# **Evaluation of the Seismic Design Criteria in ASCE/SEI Standard 43-05 for Application to Nuclear Power Plants**

**U.S. Nuclear Regulatory Commission  
Office of Nuclear Regulatory Research  
Washington, DC 20555-0001**

Manuscript Completed: January 2007

J.I. Braverman<sup>1</sup>, J. Xu<sup>1</sup>, B.R. Ellingwood<sup>2</sup>, C.J. Costantino<sup>1</sup>,  
R.J. Morante<sup>1</sup>, and C.H. Hofmayer<sup>1</sup>

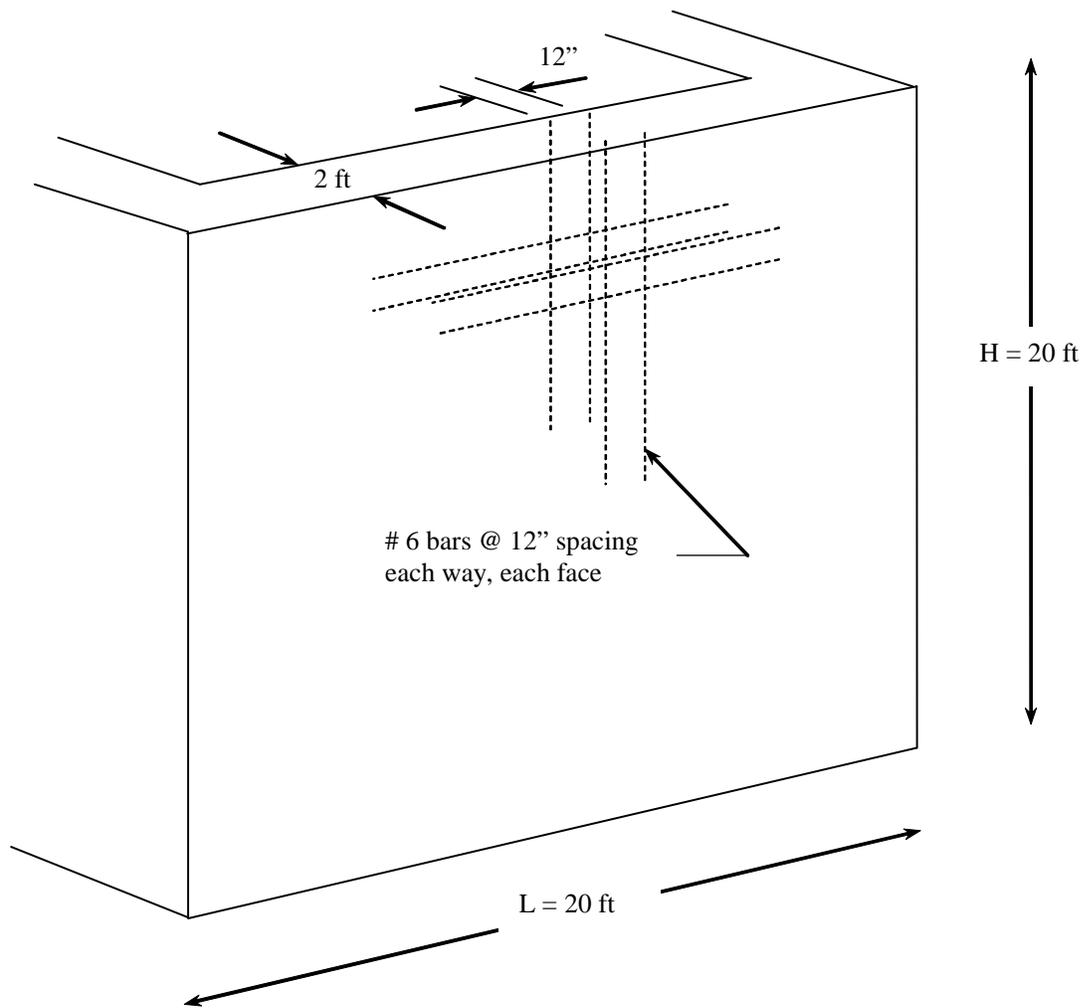
Without performing a strain compatibility analysis, ASCE 43-05 specifies that d can be determined using Eq. (A2-6). This leads to d = 144 in. (365.8 cm), which can be substituted into Eq. (A2-5) to calculate a total shear strength across the wall equal to 1,870,000 lb (8318 kN).

The calculated nominal shear load capacity using the ASCE 43-05 method is 1,870 kips (8318 kN). This shear load capacity is much higher than the 1,292 kips (5,747 kN) and 1,290 kips

Based on the above discussion, unless additional review of the methodology is performed, it is recommended that the NRC should not generically endorse the equation for calculating the shear capacity of low-rise shear walls in ASCE/SEI Standard 43-05 for purposes of design, until a consensus on this approach is developed in the concrete design community and ACI 349 is revised to reflect this change.
